In the Matter of)
) Docket 50-344
PORTLAND GENERAL ELECTRIC COMPANY,)
) (Control Building Proceeding)
et al)
)
(Trojan Nuclear Plant))

I hereby certify that on June 29, 1979, Licensee's letter to the Director of Nuclear Reactor Regulation dated June 29, 1979 and an attachment entitled "Request for Additional Information, Trojan Nuclear Plant, Proposed Control Building Design", have been served upon the persons listed below by depositing copies thereof in the United States mail with proper postage affixed for first class mail.

Trojan Nuclear Plant
Docket 50-344
License NPF-1

Enclosed are responses prepared by Bechtel Power Corporation to an additional 14 of the 50 questions submitted in your letter of May 18, 1979. In accordance with our discussion with your staff, we expect to transmit responses to the remaining questions by July 6.

Figure 3-5

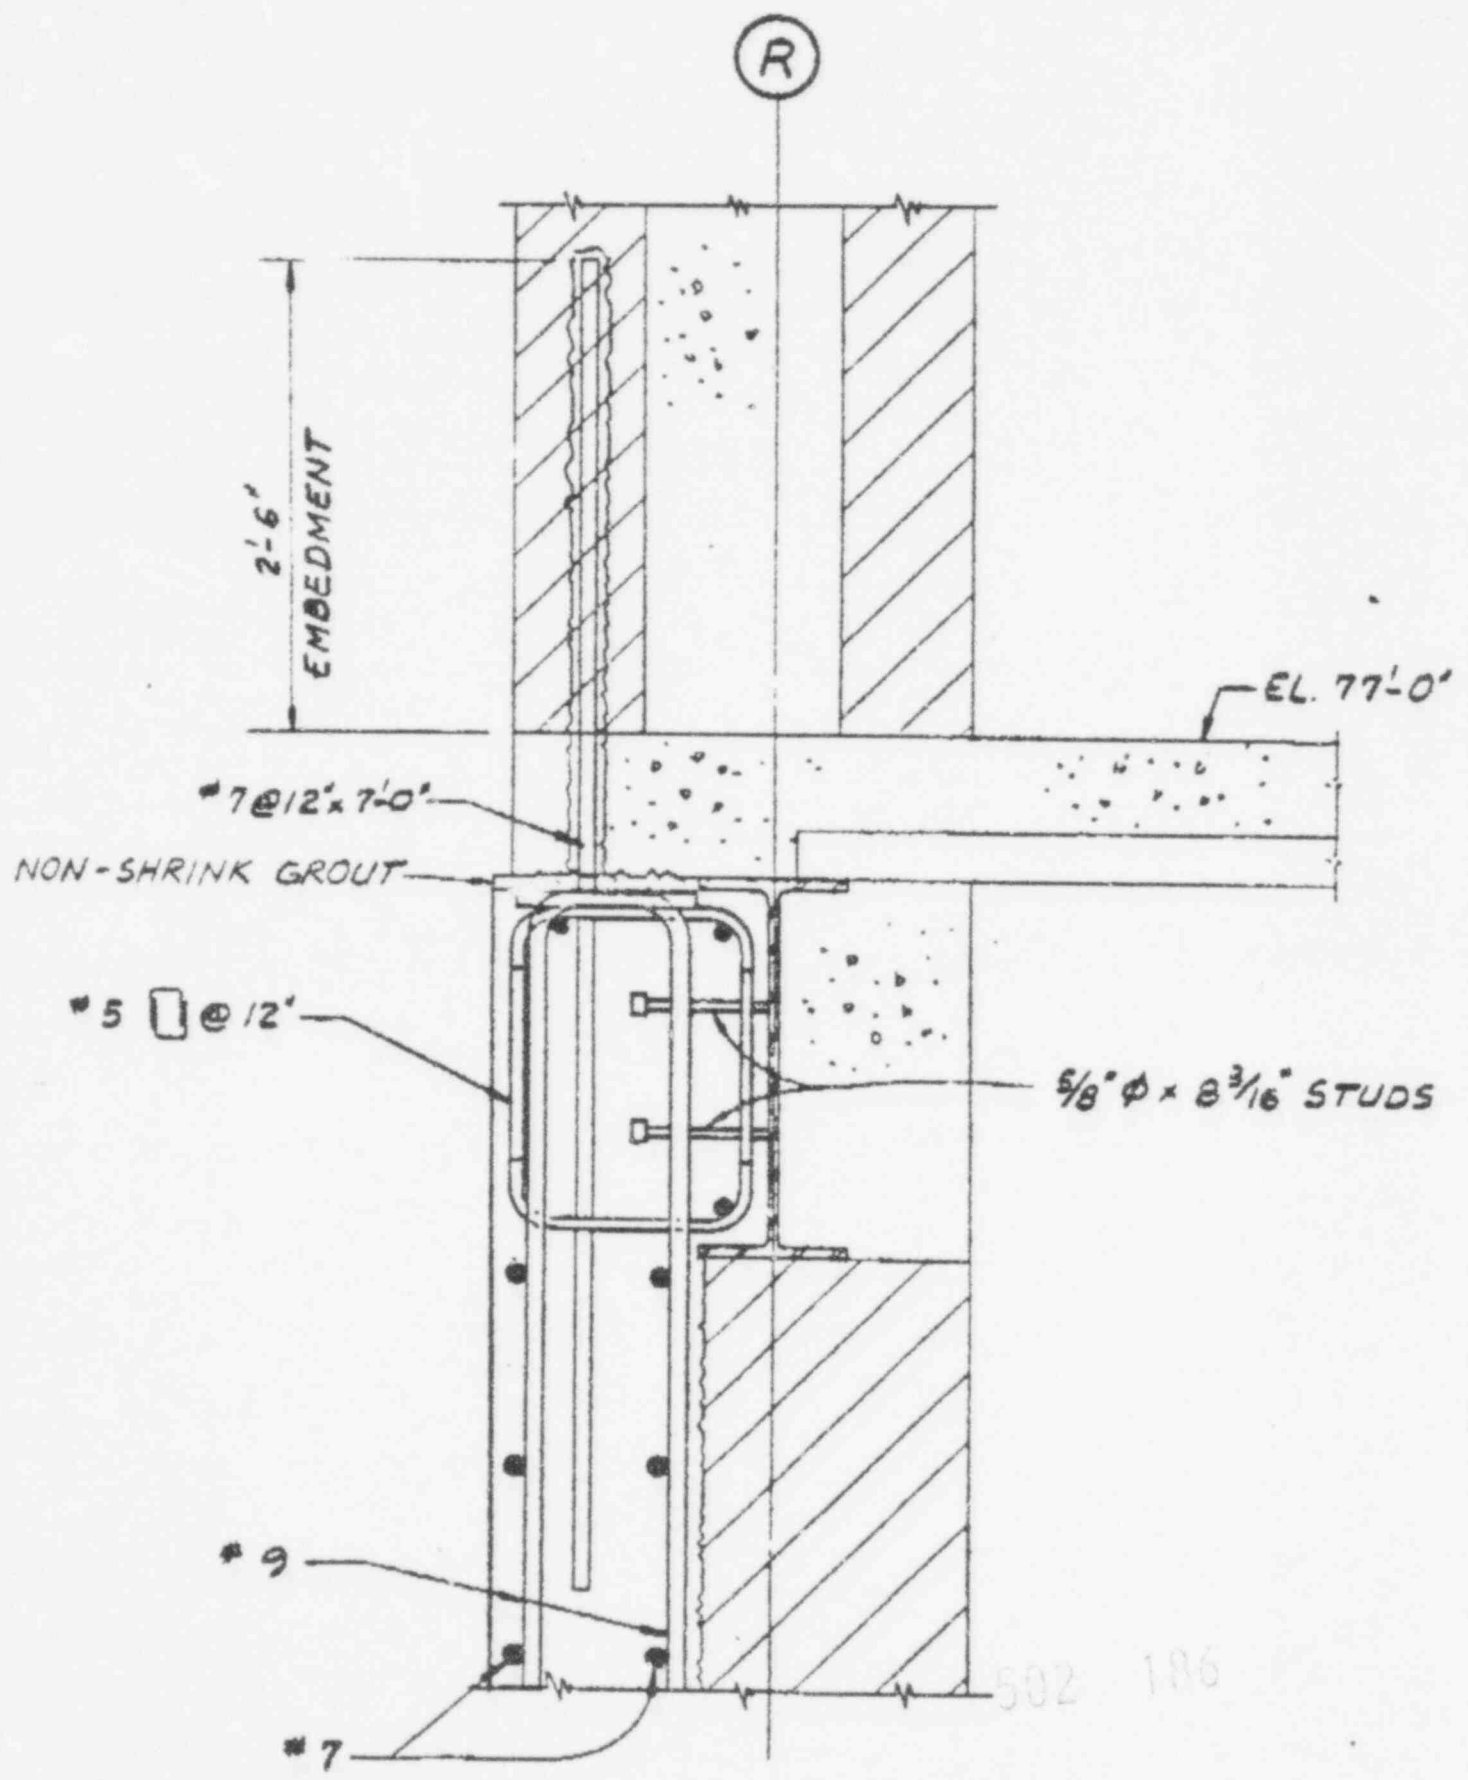
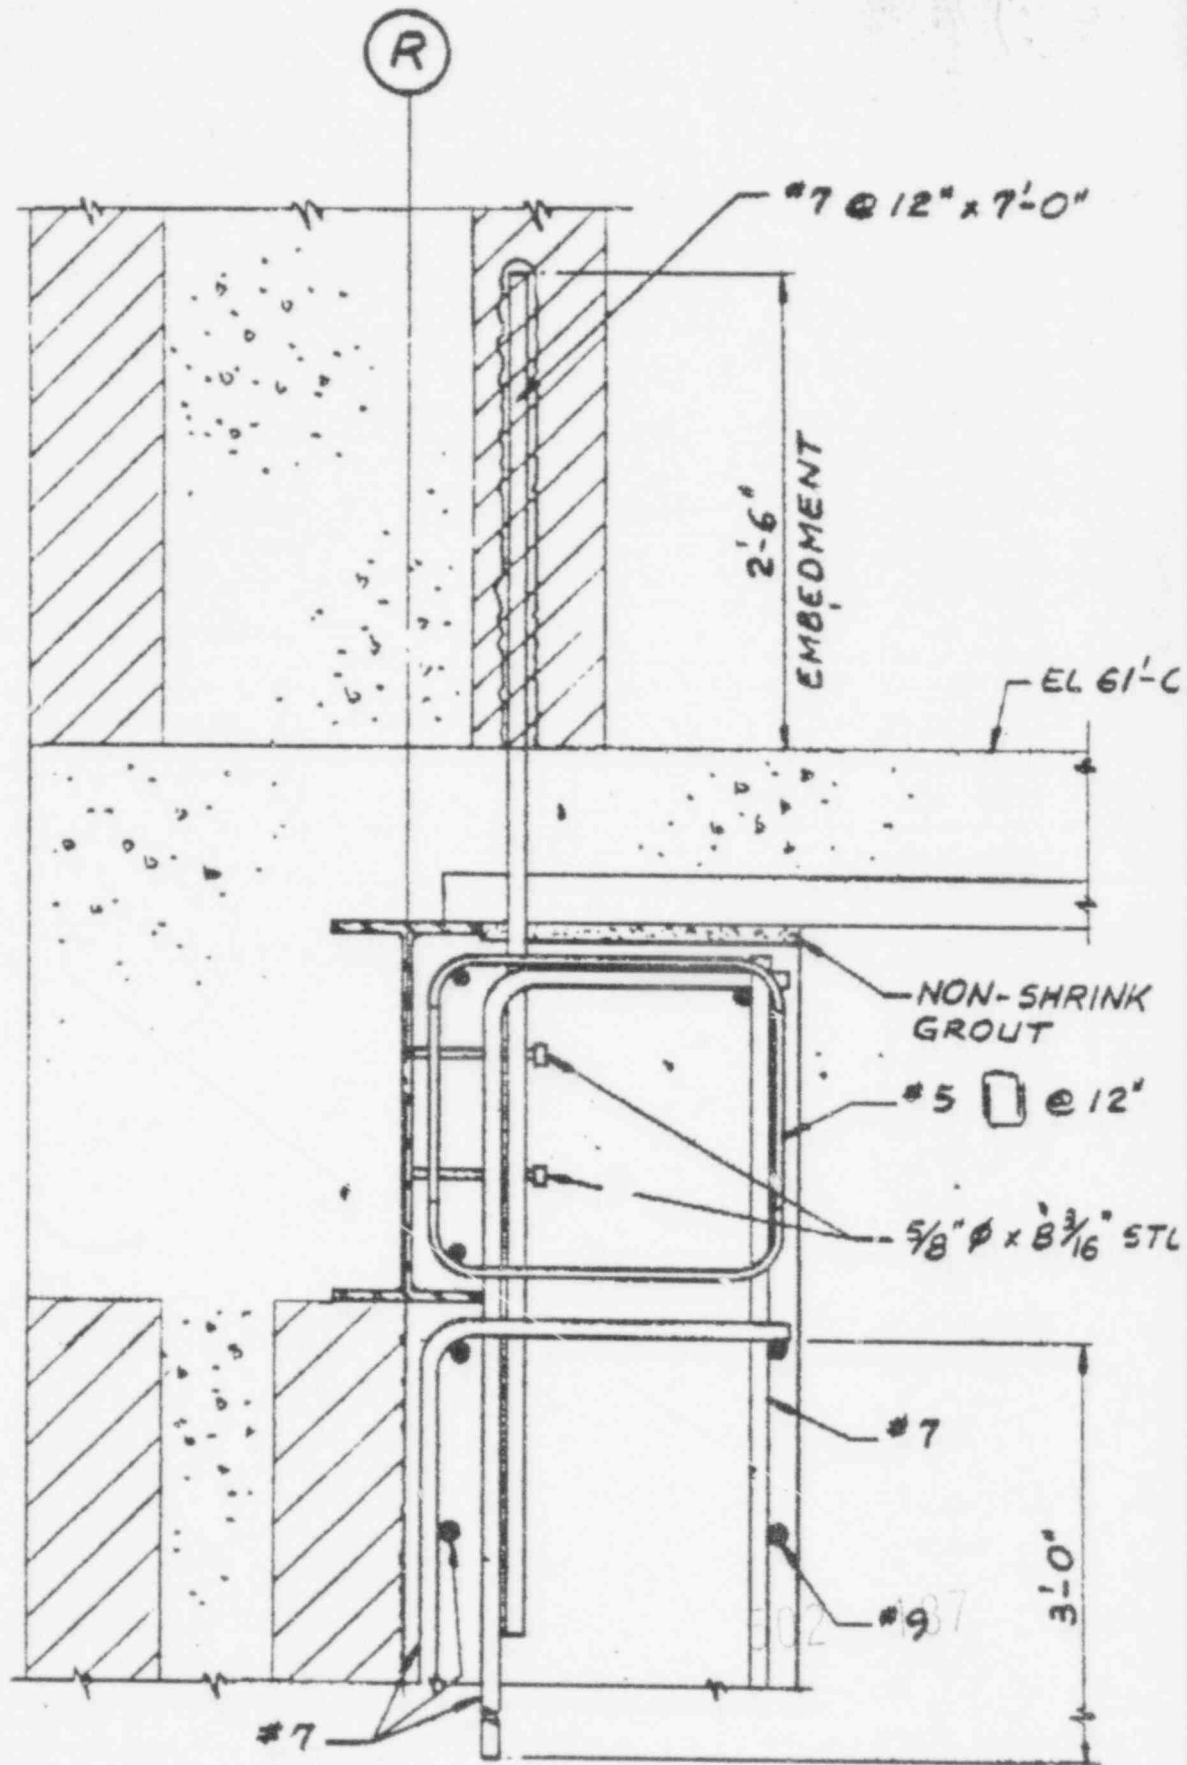
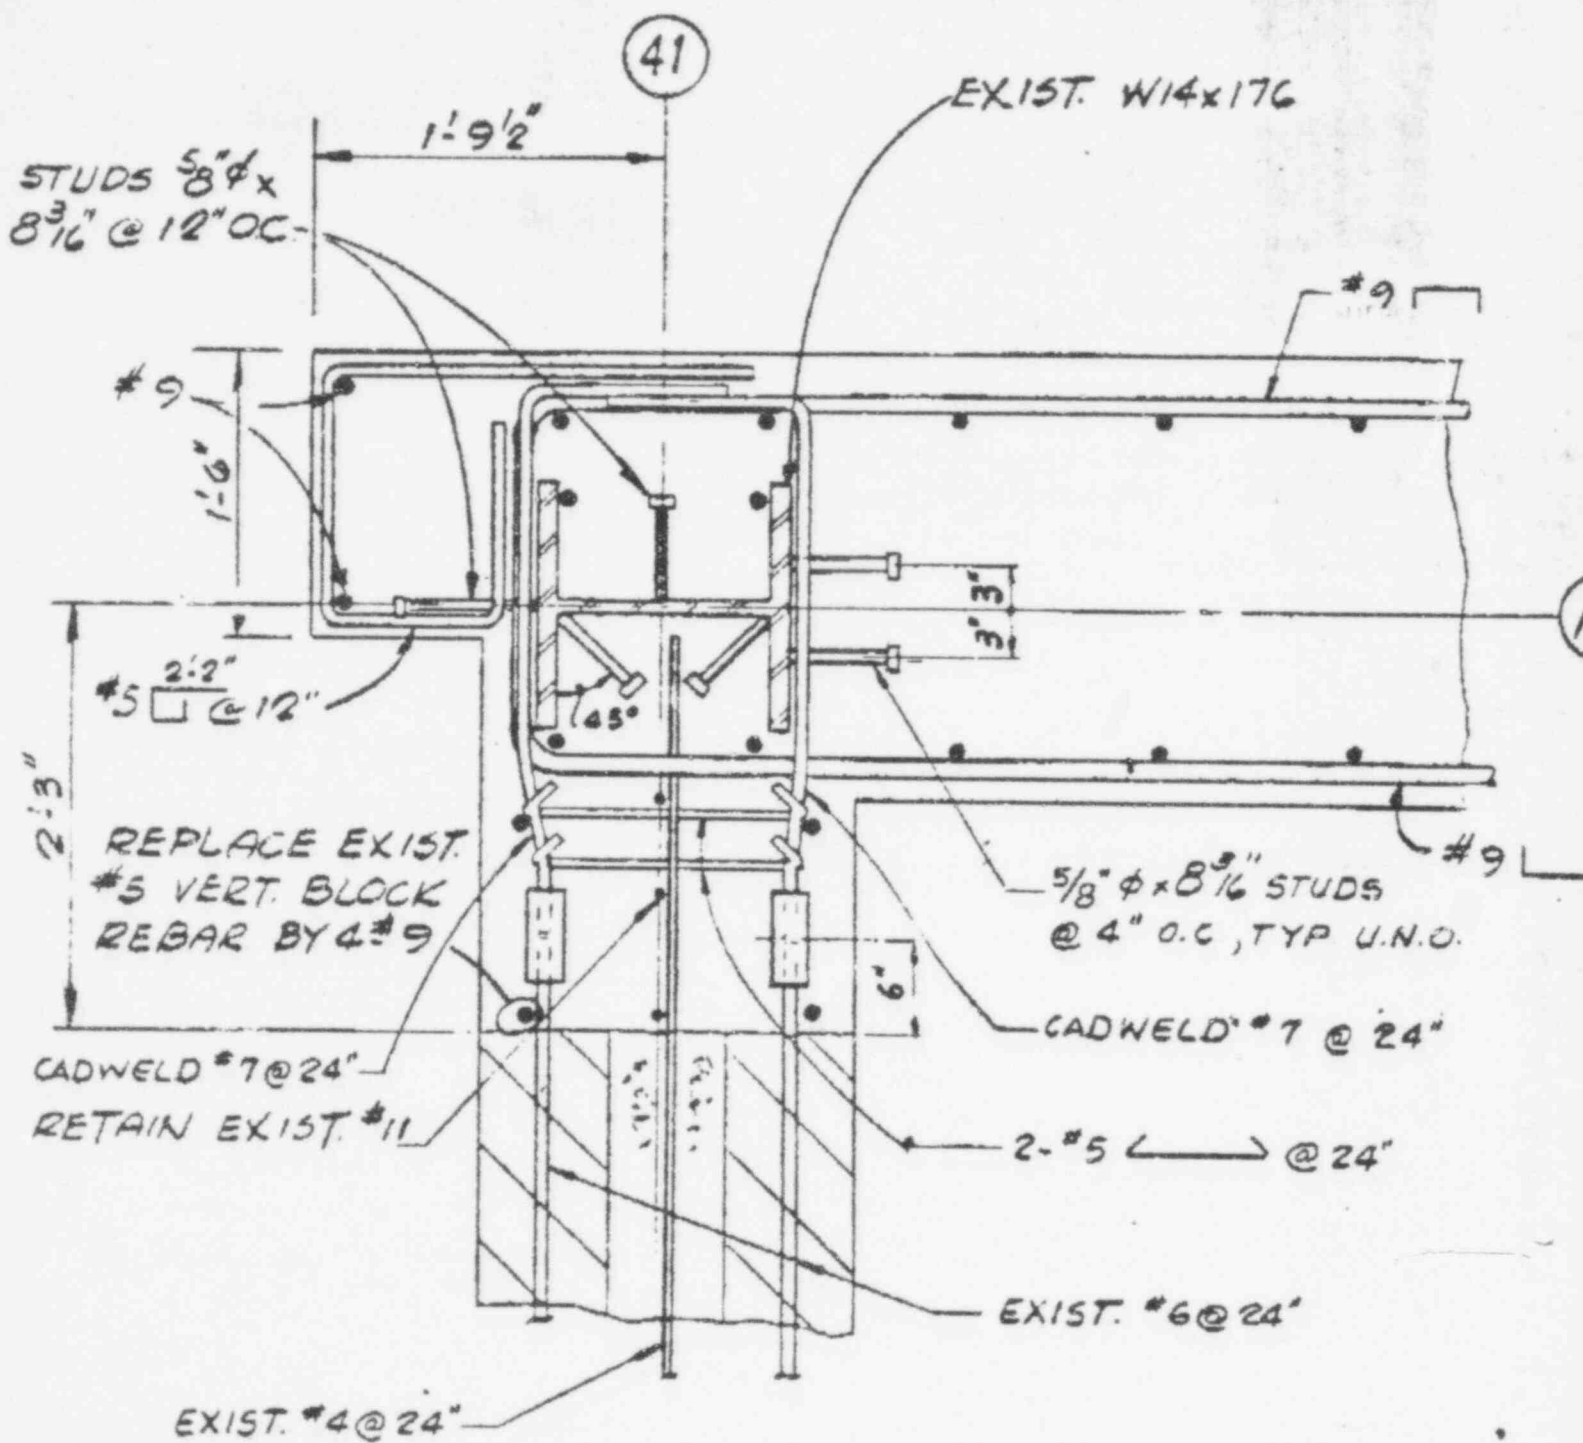
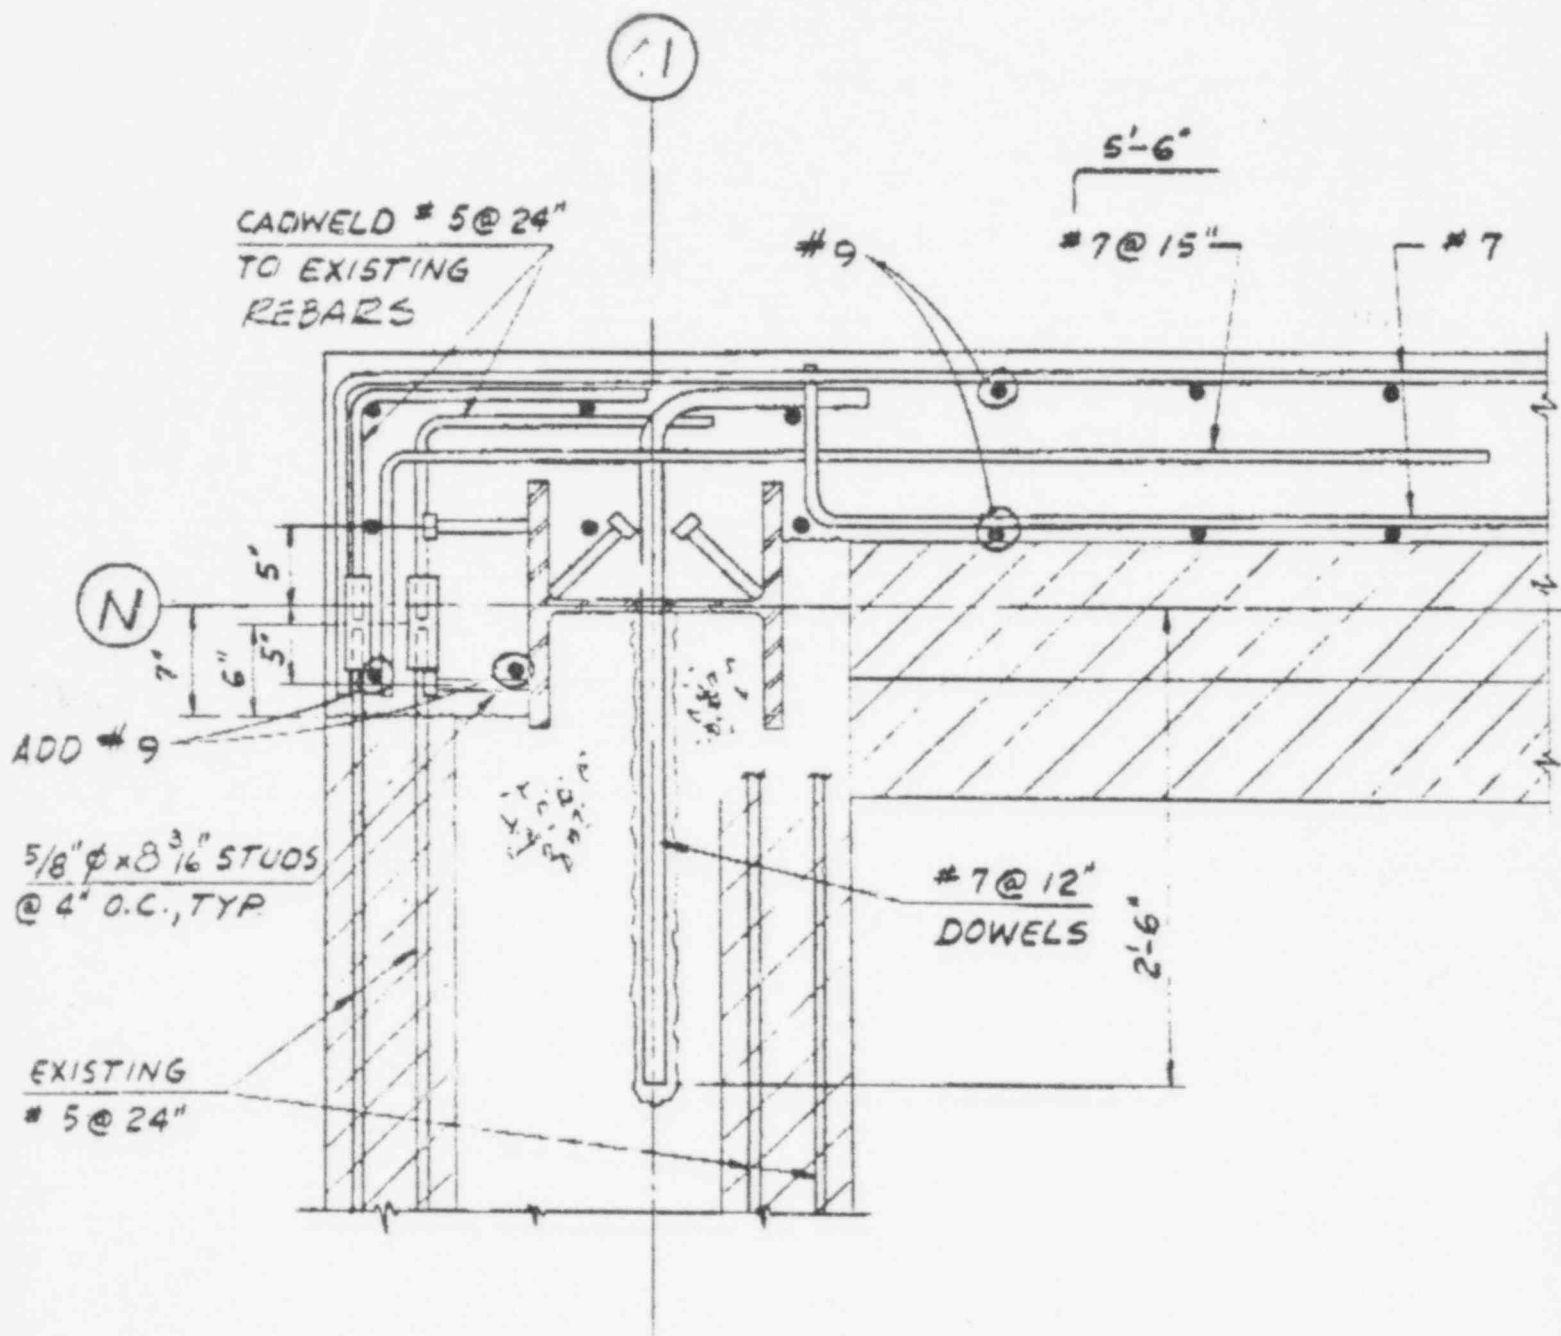
Provide clear, detailed sketches and descriptions of the connection interfaces of the additional walls to the existing structure. Additionally, describe the methods by which the effects of concrete creep and shrinkage (causing tension in the walls and/or a reduction in assumed dead weight) have been factored into the design of these additional walls. Describe and justify in detail the design and the procedures for the connections of the new walls to the existing structure.

Detailed sketches of the connection interfaces between the new walls and the existing structure are attached. The final design may require some minor revisions to the actual sizes and spacings of the rebar and studs. The sketches show representative connection details that will be used. The connection interfaces are discussed below.

Typically, where steel beams occur at a horizontal interface, studs are used to transfer shear forces and vertical rebars are used to transfer tension forces. At horizontal interfaces where steel beams do not exist, vertical rebars make the connection. In some cases friction type A-490 bolts are also used in the connections between the new walls and the existing concrete.

The typical treatment for vertical interfaces is to expose the columns and weld studs to them. New rebars are spliced with the exposed horizontal existing rebars by cadwelding. Drilled and grouted horizontal rebars are also used to make the connections.
